## Planning Commission Staff Report

**MEETING DATE:** FEBRUARY 5, 2014

**SUBJECT:** Z13-12: REQUEST TO AMEND ORDINANCE NOS. 1597 AND 1956 AND REZONE APPROXIMATELY 17.5 ACRES OF REAL PROPERTY WITHIN THE COPPER RANCH PLANNED AREA DEVELOPMENT (PAD), GENERALLY LOCATED SOUTH AND EAST OF THE SOUTHEAST CORNER OF WARNER AND RECKER ROADS FROM MULTI FAMILY-MEDIUM (MF-M) ZONING DISTRICT WITH A PLANNED AREA DEVELOPMENT (PAD) OVERLAY TO SINGLE FAMILY-DETACHED (SF-D) ZONING DISTRICT WITH A PLANNED AREA DEVELOPMENT (PAD) OVERLAY.

6-PACK  
LOT LAYOUT

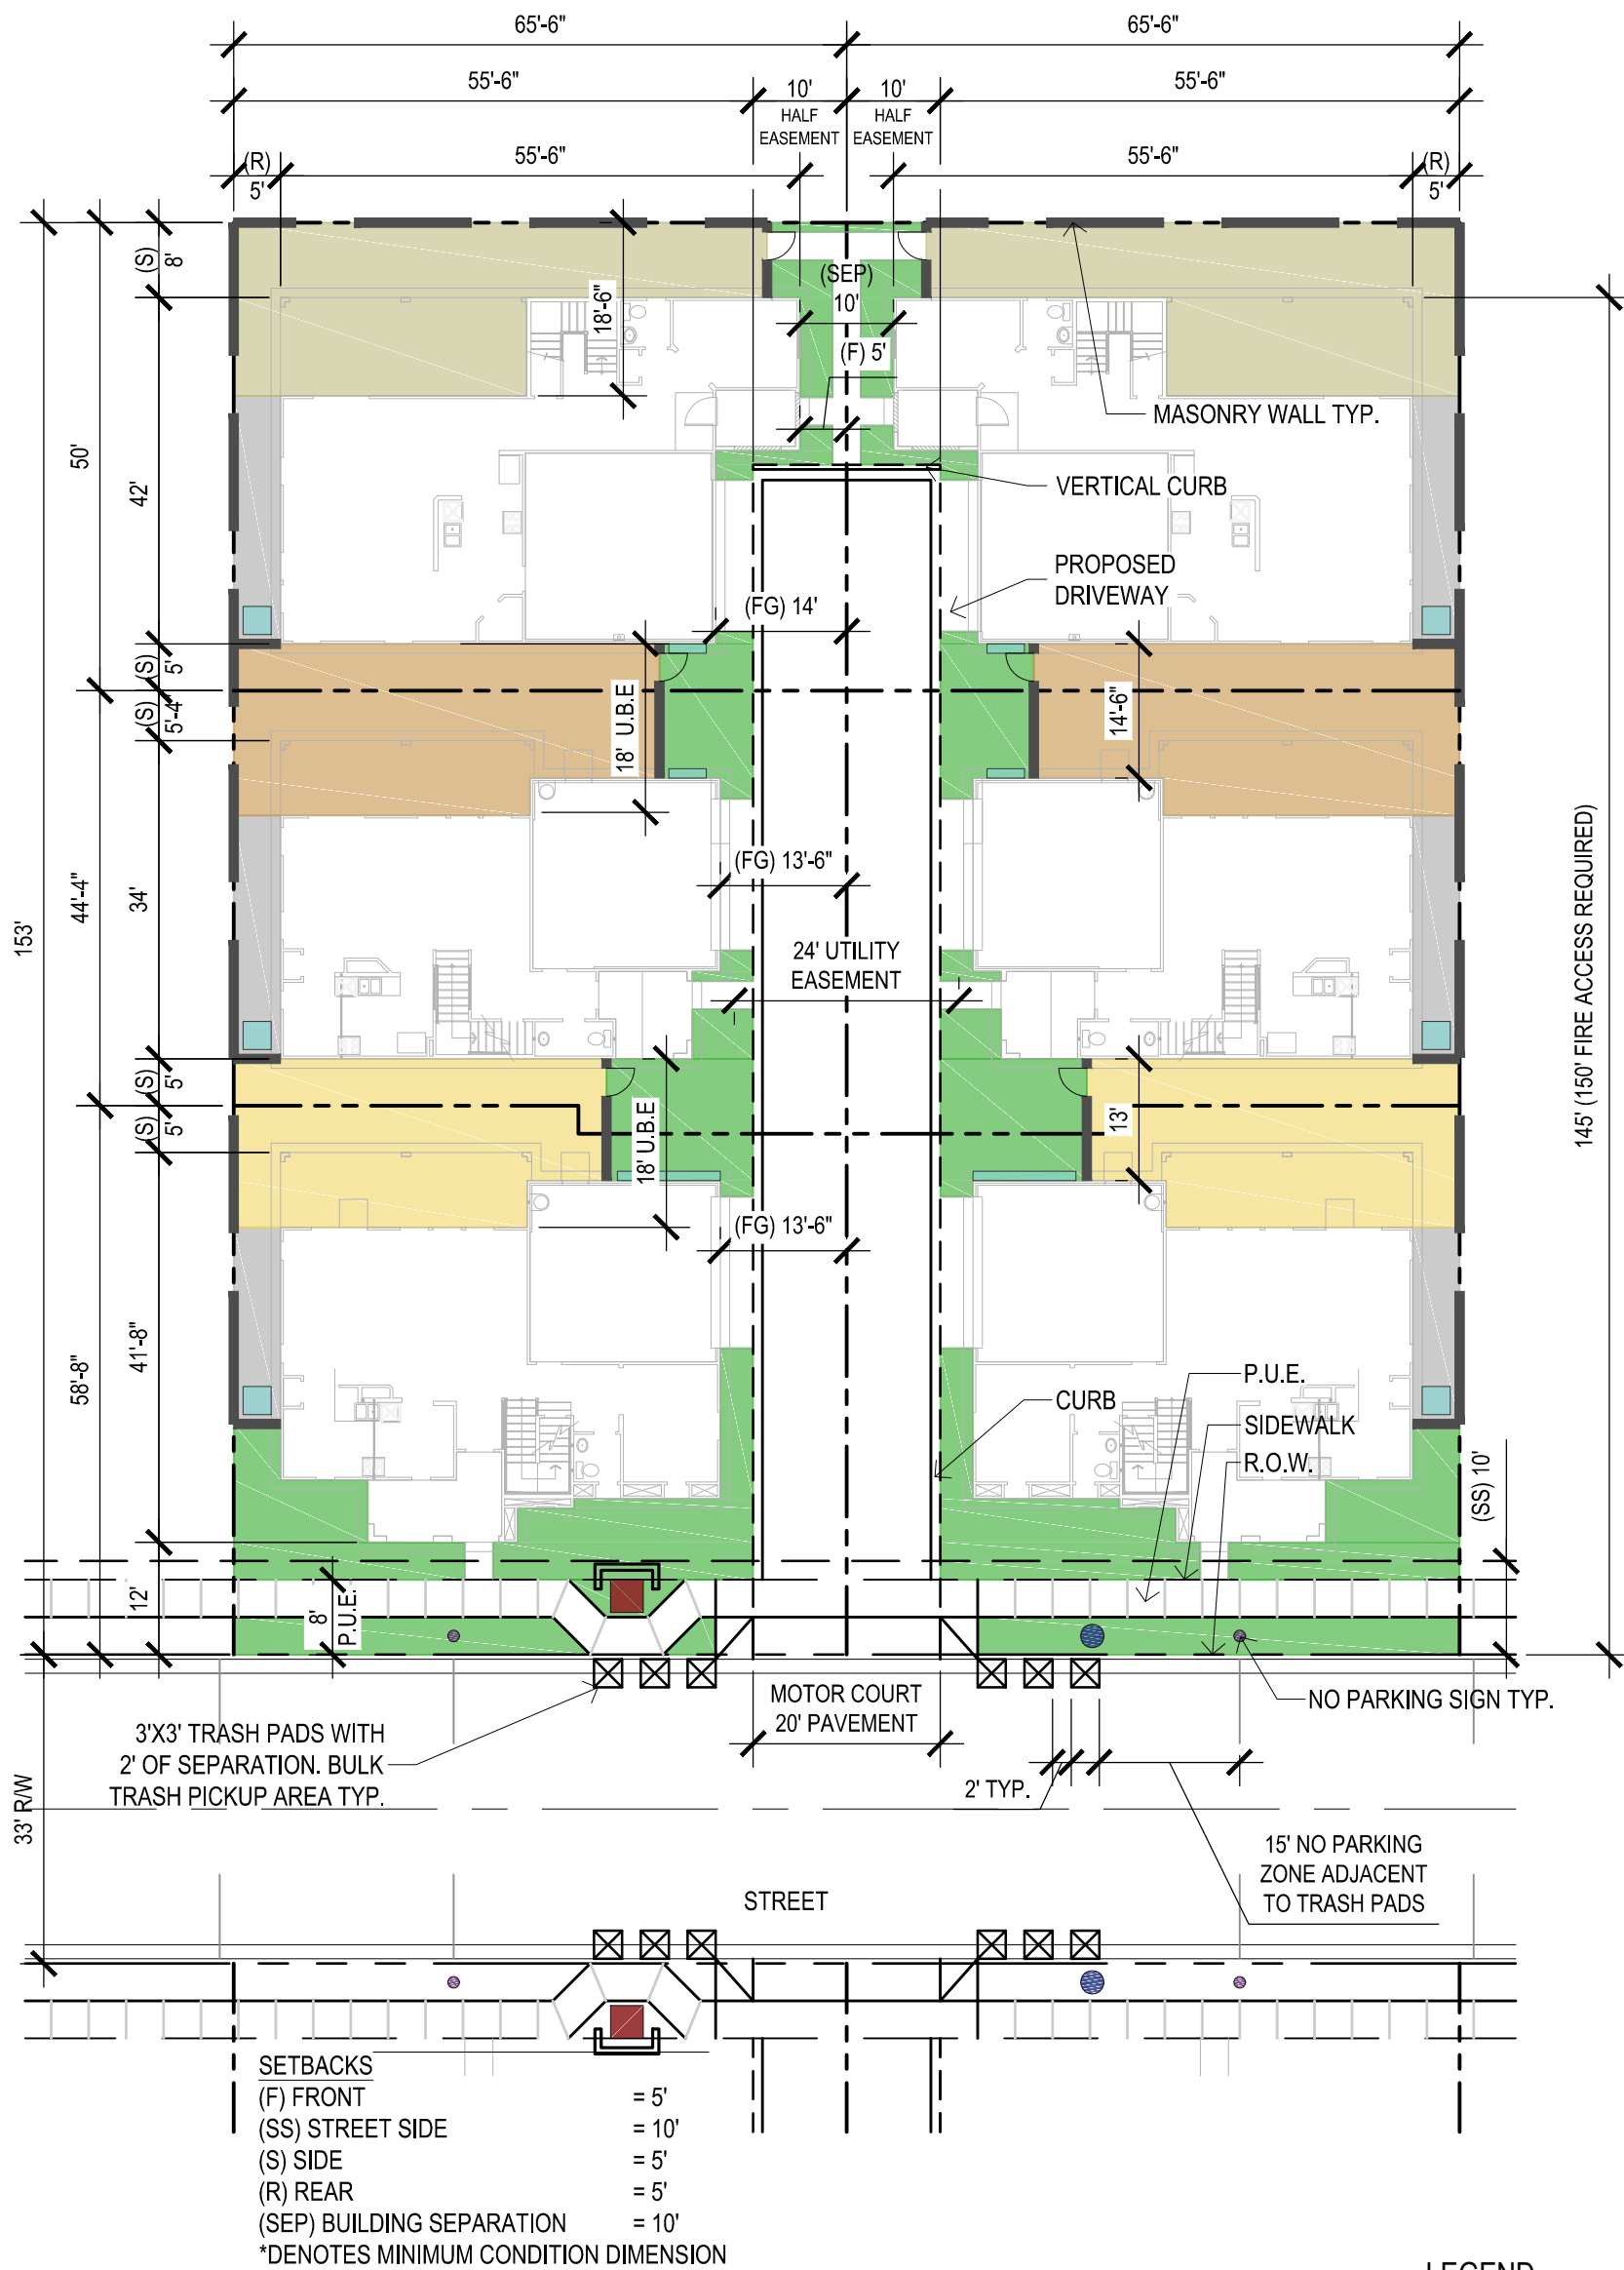
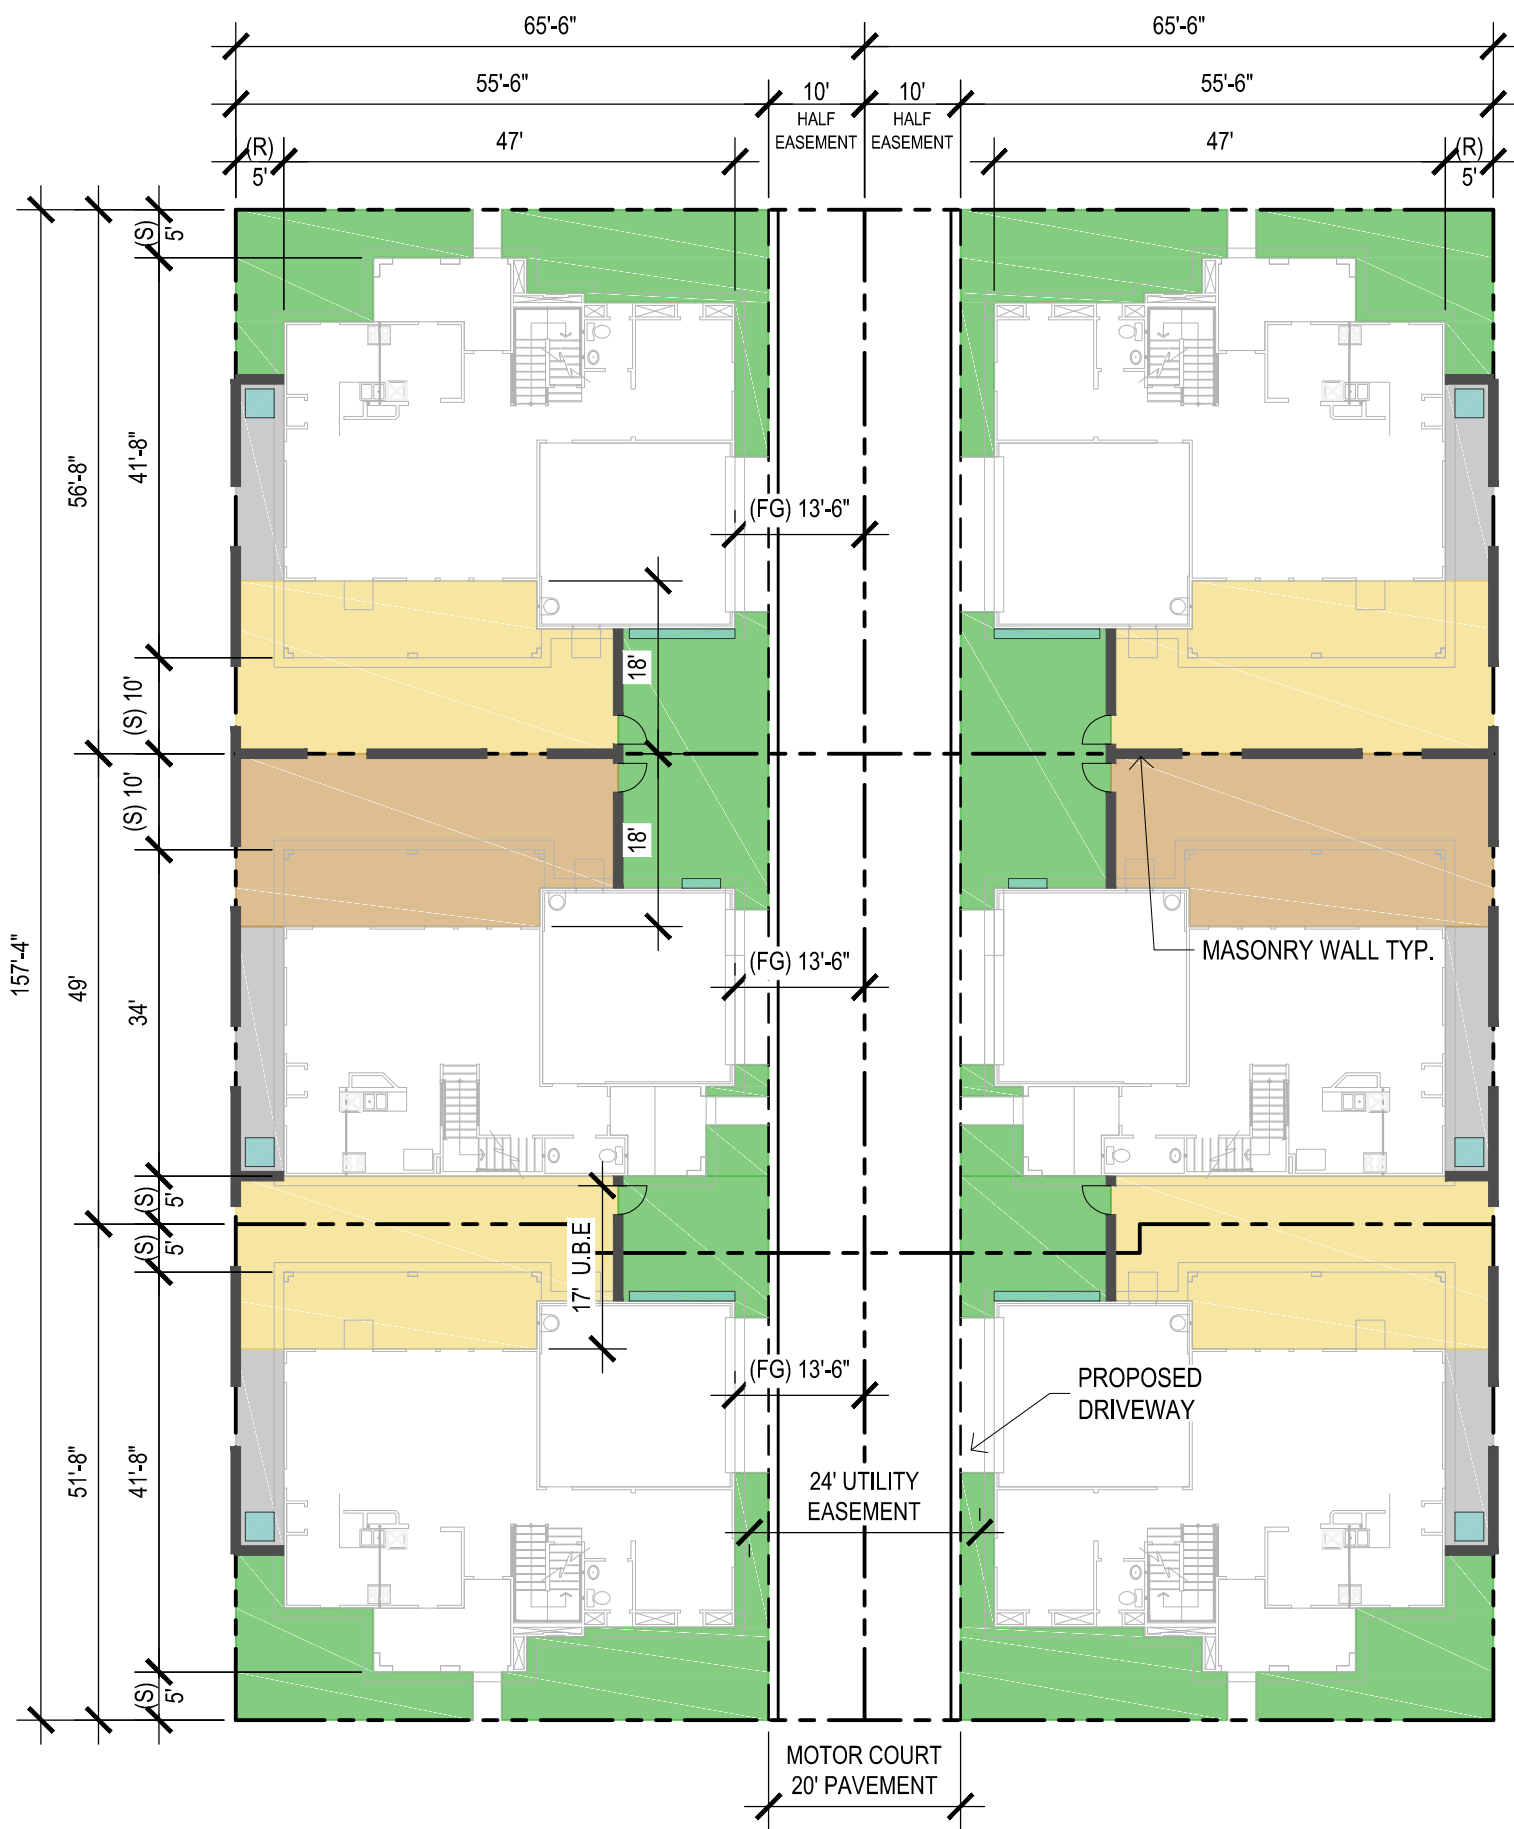
At the January 8, 2014 public hearing, the Planning Commission expressed concerns specifically on the egress from the garages at the end of the motor courts, functionality of the setbacks, and accessibility to the designated refuse pads by residents in the 8-pack module. Since then, the applicant has submitted revised plans addressing the following:

- Lot coverage was reduced from the proposed 62% to 57% for only 18 lots at the end of the 5- and 6-pack modules
- The housing product footprint for the rear units in the 6-packs was adjusted to widen the garage door separation from 27' to 28' and a vertical curb added to the rear edge of the motor court

*Engineering Evaluation:* accepts the revised layout for the end-lots layout in the 6-pack groupings indicating that the maneuverability is improved by increasing the distance from face to face of the garages to 28' and with the implementation of a vertical curb; however, states that the design of future residential alleys should be no less than 24' wide pavement.
